Addendum No: Three (03)

Project: Saint Martin Parish Sheriff's Office: Enforcement Complex
Date: 06 January 2022
To: All of Record Holding Contract Documents

ACCESS CONTROL ROUGH-IN

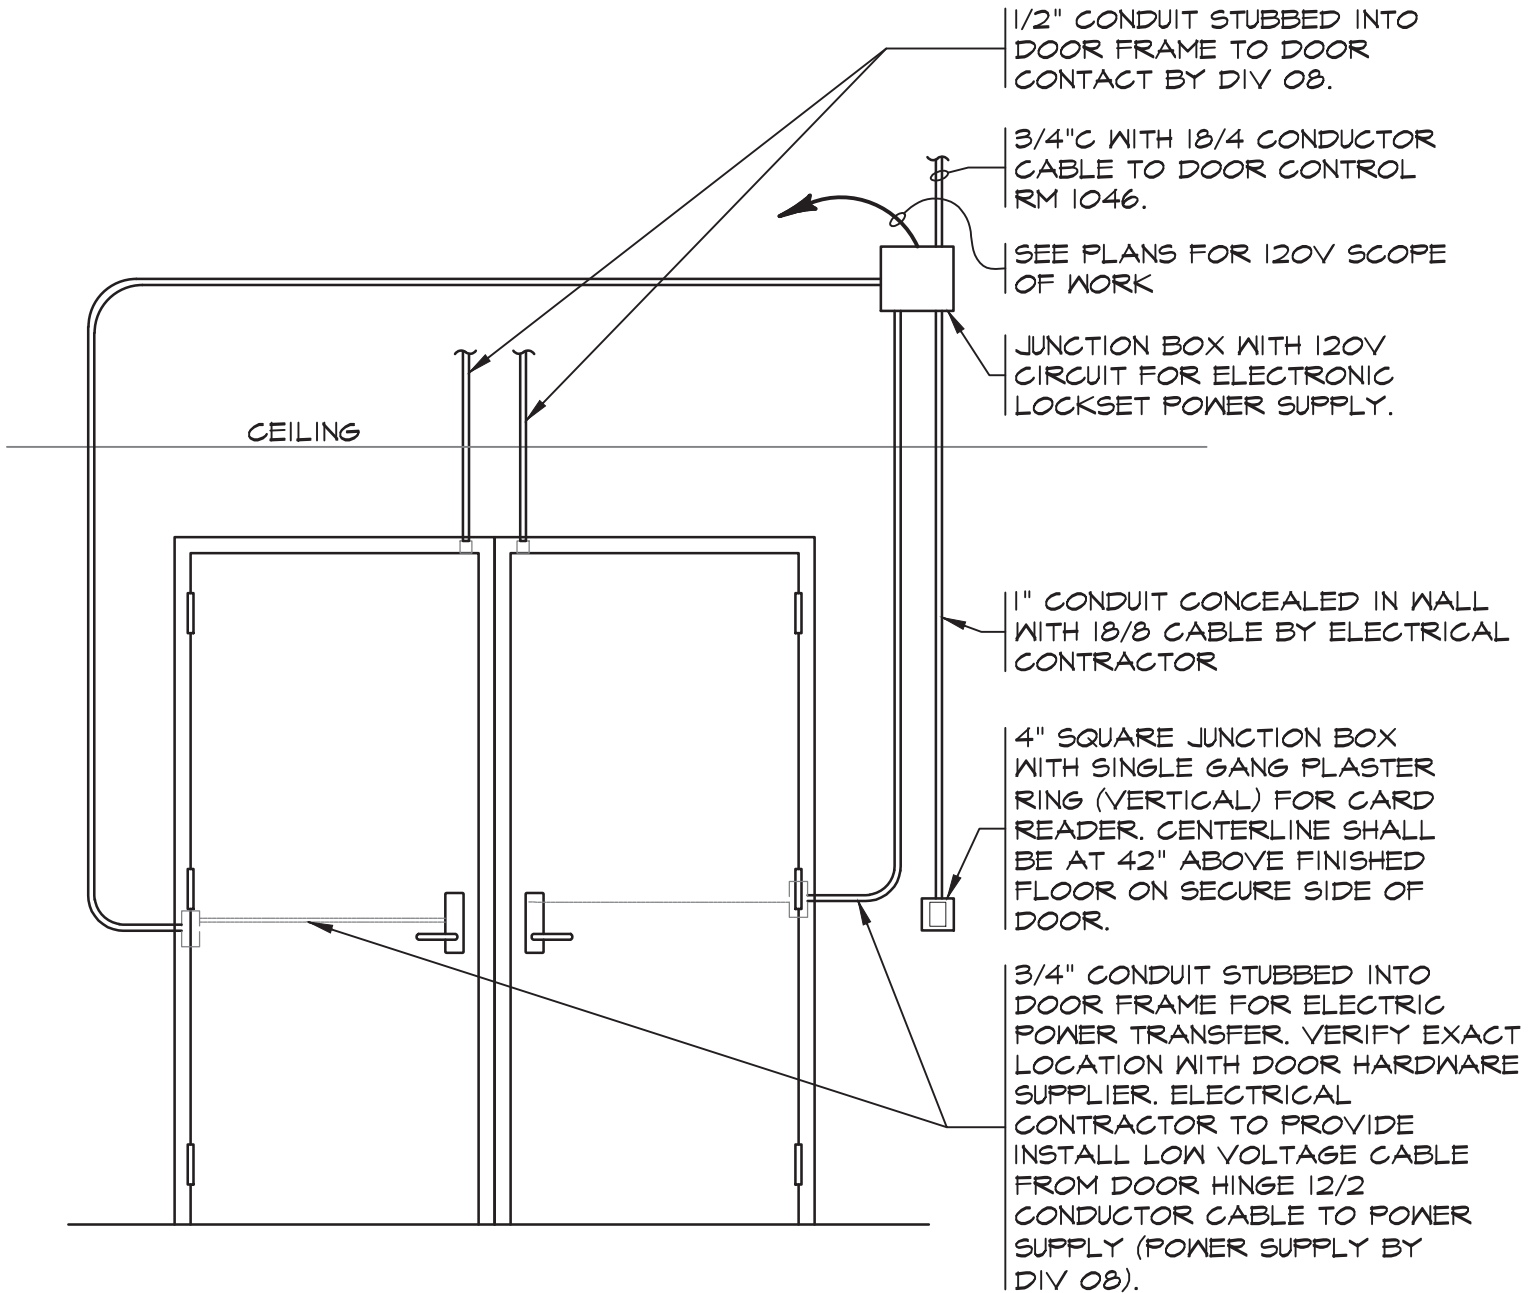
19. **Clarification:** Electrical Contractor to review Div 08 specifications and provide any and all power and controls rough in and wiring for door access systems mentioned.

- a. Door 1001B, 1001C, 1114, 1116, 1023, 1078, 1080, 1006, 1021, 1068, 1069, 1079, 1092, 1046, 1117, 1123, 1124 to follow attached sketch for door access control rough in detail 1.

- b. Door 1054C to follow attached sketch for door access control rough in detail 2
 - c. Electrical contractor to verify low voltage wiring types during submittals from Div08 door hardware vendor.
